City of Santa Fe, New Mexico

memo

FROM: Lani McCulley, Senior Planner, Historic Preservation Division *LJM*

2025-011550-HDRB. 539 Garcia St. Downtown & Eastside Historic District. Contributing. Geisler Projects, agent for Matt and Penelope Rembe, owners, proposes to construct a 108 sq. ft. addition to a height of 10'-6", where the maximum allowable is 10'-10". A 206 sq. ft. portal to a height of 10'-3". Replace windows and doors on the residence, convert the garage to a casita by altering the garage door to a window, and installing a new window, and reroof, and stucco both buildings. An exception is requested to section 14-5.2(D)(2)(d) for constructing an addition within 10'-0" of the primary façade.

② Proposed West Elevation Main House
1/4" = 1'-0"

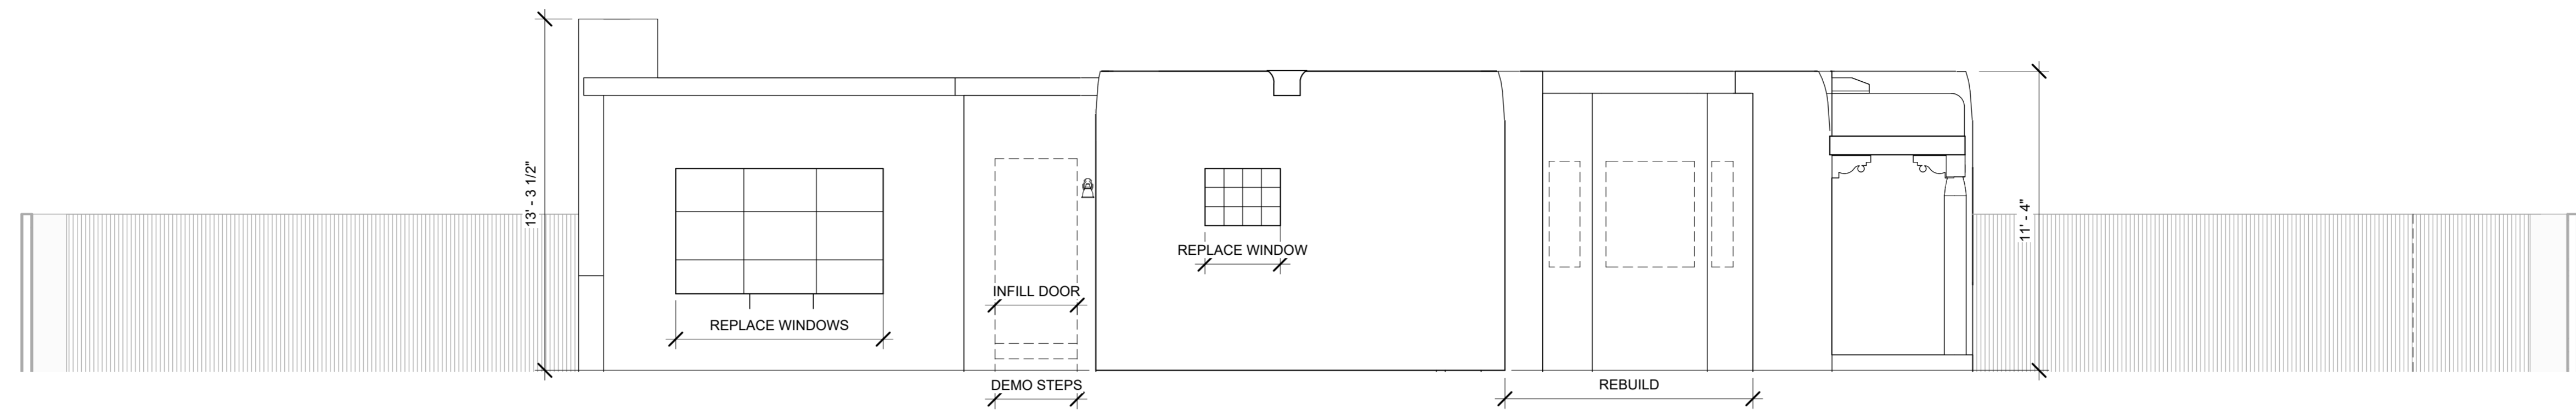
- 1) Remove the 1980s addition of the bay window on the west elevation.
- 2) Construct a 33 sq. ft. addition to a height of 10'-6" where the maximum allowable is 10'-10". Exceptions are requested to section 14-5.2(D)(2)(d) for constructing an addition within 10' of the primary façade.

Applicant Response: The proposed addition replaces an existing non-conforming bay window that is already located within close proximity—approximately 1–2 feet—from the primary south façade.

Staff Response: Staff finds that this criterion is met. The non-historic addition of the bay window area is not in keeping with the architectural style of the home. The new addition will

Staff Response: Staff finds that this criterion is met. The additional 60 sq. ft. of the addition will make the area where the bay window is currently a more livable space for the residence. The space is currently not a livable space.

Staff finds that the exception criteria have been met and recommends approval of the exception to section 14-5.2(D)(2)(d) for constructing an addition within 10' of the primary façade. Staff also recommends approval of the other elements of the application as they comply with 14-5.2(D)

② Garage Elevation Proposed
1/4" = 1'-0"

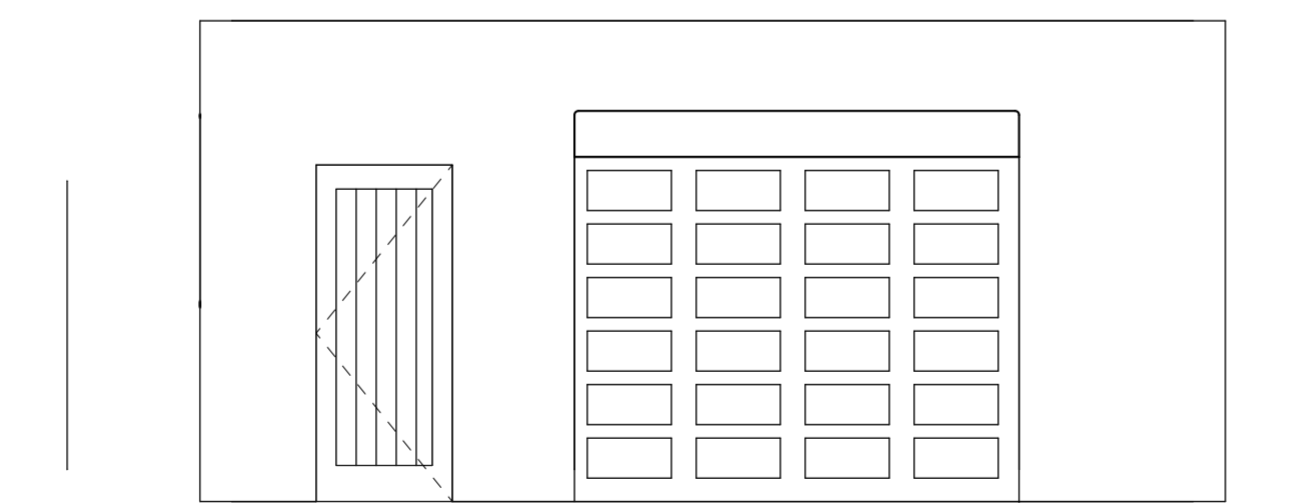
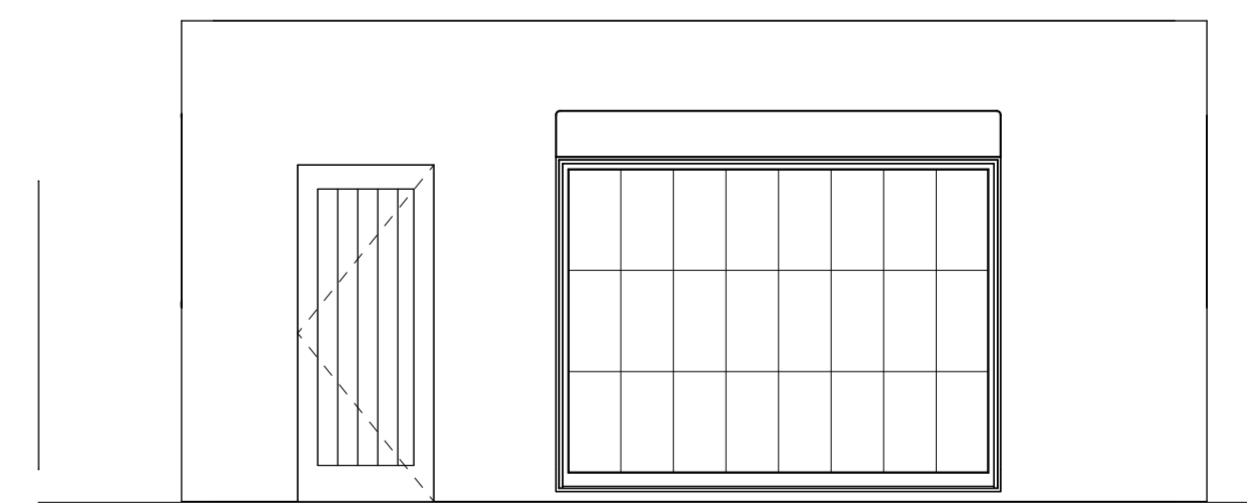
- 12) Alter the garage door to a window. The window will be a larger 8'-11" wide by 6'-6" high window with a seven-over-three pattern to match the window under the west portal of the residence. The garage door is on the primary façade; however, it is excluded from the primary façade.
- 13) Replace the two existing windows and install a new window on the non-primary façades.
